# METROPOLITAN GOVERNMENT OF NASHVILLE AND DAVIDSON COUNTY

## STAFF RECOMMENDATION

317 Broadway  
September 19, 2012

**Application:** New construction-rear addition and exterior alterations  
**District:** Broadway Historic Preservation Zoning Overlay  
**Council District:** 19  
**Map and Parcel Number:** 09306402100  
**Applicant:** Preston Quirk, architect  
**Project Lead:** Robin Zeigler, robin.zeigler@nashville.gov

FRONT ELEV.

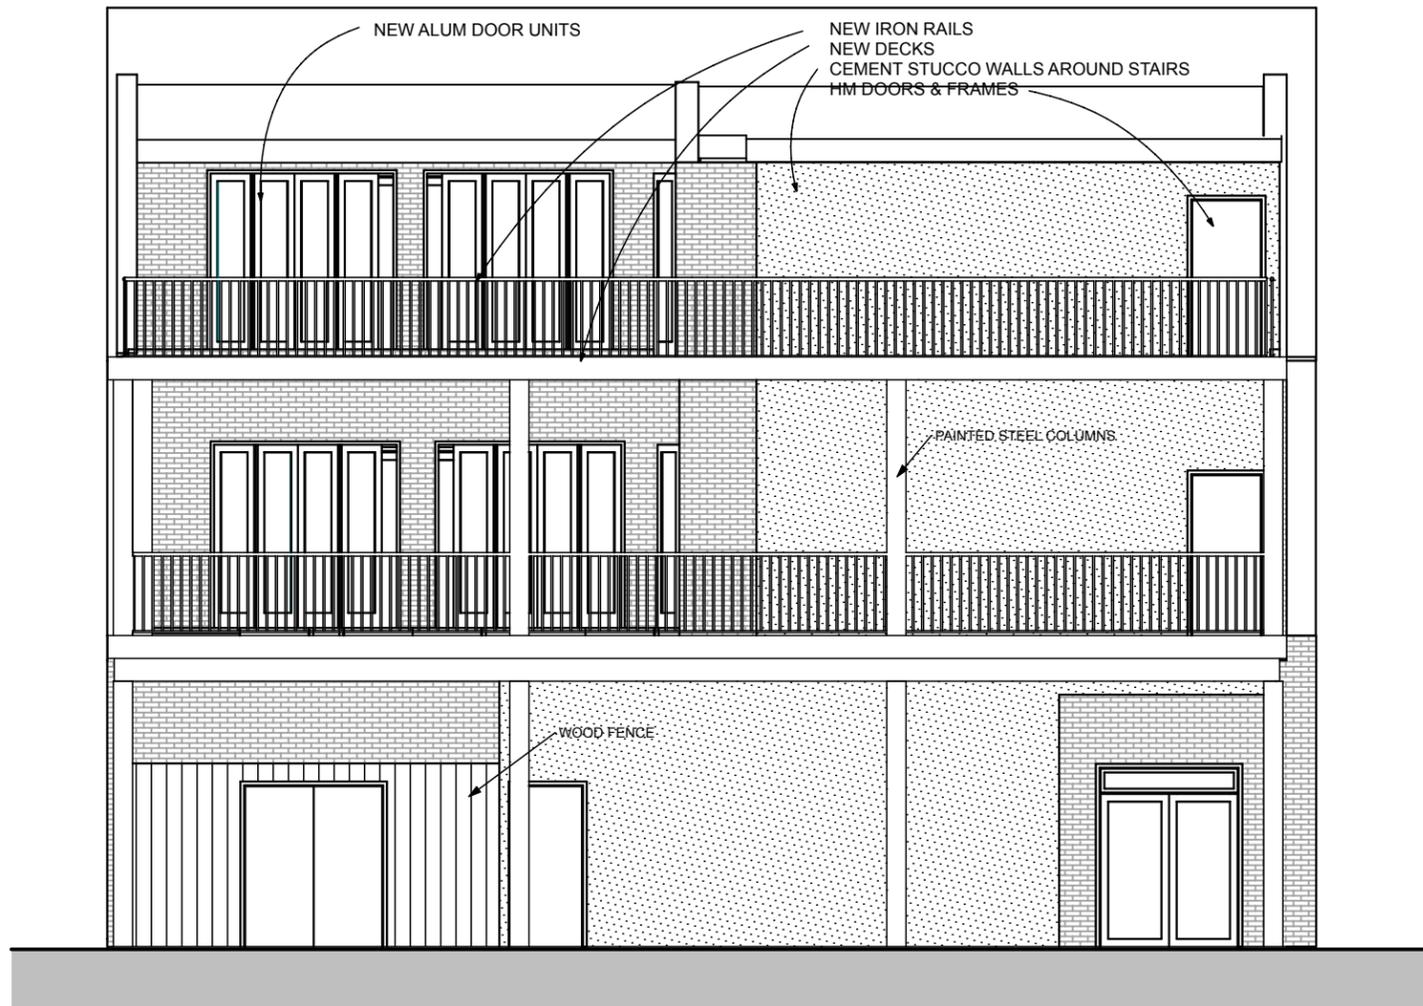
The glass was repaired in 1990 with new caulking and 16 missing or broken pieces were replaced with black spandrel glass. In more recent years, some pieces have been replaced with matching Plexiglas squares. The application now requests complete removal of the glass/Plexiglas veneer. According to the design guidelines historic storefronts should be retained and repairs made where needed; therefore, staff finds removal of the glass veneer to be inappropriate and does not meet section II.A.1 of the design guidelines. Cracks in original glass pieces can be sealed. Broken pieces can be replaced with plexiglass or spandrel glass and the visual result is essentially seamless.

Doors and Entryways: The application includes relocation of the primary entrance and the installation of a new secondary door on the main façade within the current recessed entry. The storefront windows are not original as they were replaced with aluminum accordion windows sometime after 2004; however the configuration of the storefront does not appear to have changed. The existing entrance has a tile floor and earlier photographs show an entrance at the current location. In keeping with the design guideline's requirement to retain original entryways, staff does not recommend moving the current doorway and adding a second one. The proposed action does not meet section II.A.2 of the design guidelines.

Windows: The existing windows were repaired with some lintel replacements in 1990. The applicant requests to remove the existing windows and alter the existing dimensions of the openings to accommodate double-doors with transoms and a railing. The guidelines require that existing window openings, as well as windows themselves be retained. In addition, it states that new window openings should not be introduced and balcony rails are inappropriate. (Railings have only been approved on non-contributing buildings.) Staff recommends repair of the existing windows, if needed, but not removal and alteration of the openings' dimensions. The proposed action does not meet section II.B.1 of the design guidelines for "upper facades."

Staff recommends approval of the rear addition finding the addition to meet section V.H. of the design guidelines for additions. Staff recommends disapproval of all proposed alterations to the front façade finding the alterations do not meet Section II of the design guidelines for rehabilitation.

REAR ELEV

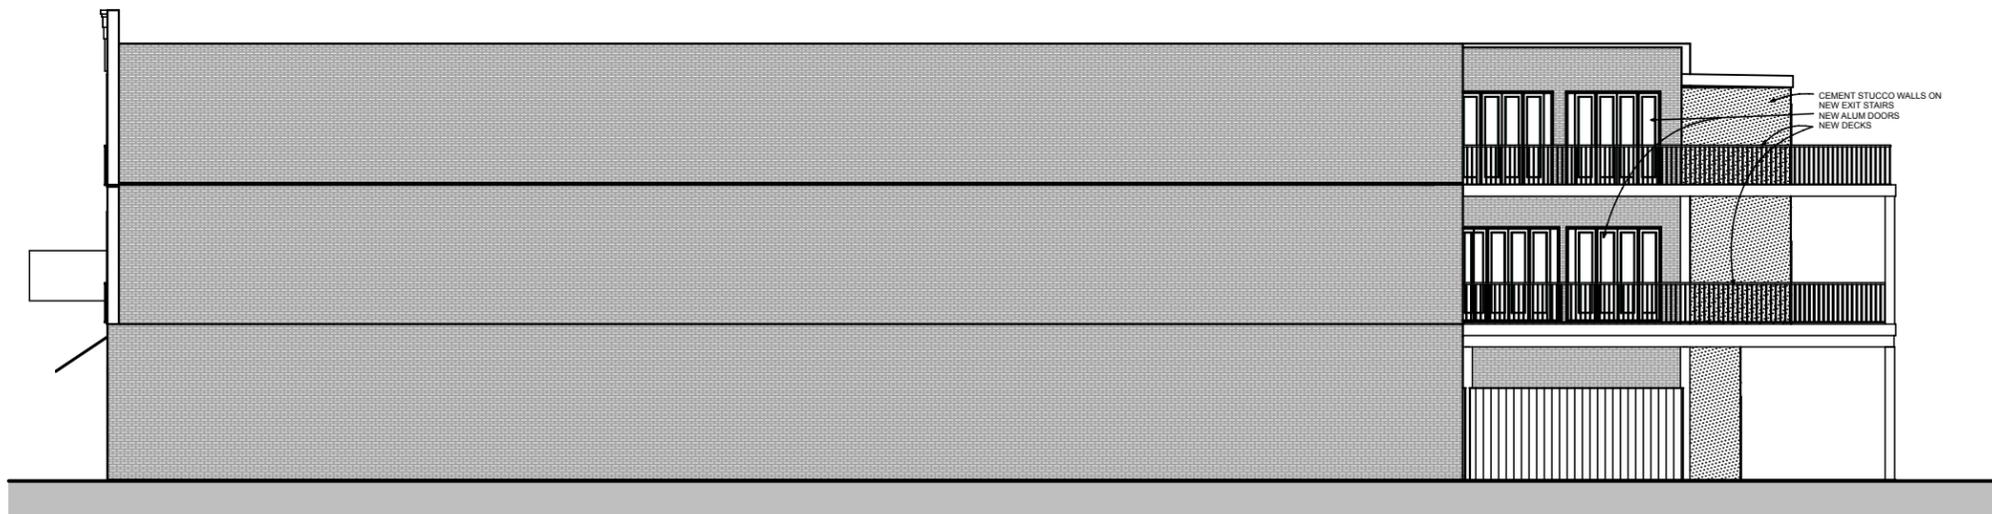
Additions to Existing Buildings: The addition is a three-story uncovered deck with an enclosed stairwell. The addition is located on the rear and will not be seen from Broadway. It will require the alteration of some existing windows and doors; however, these are not character defining features because of their location on the rear. Materials for the addition include a stucco enclosure for the stairwell, iron railings, aluminum doors, and painted steel posts. Staff finds that the rear addition meets the design guidelines.
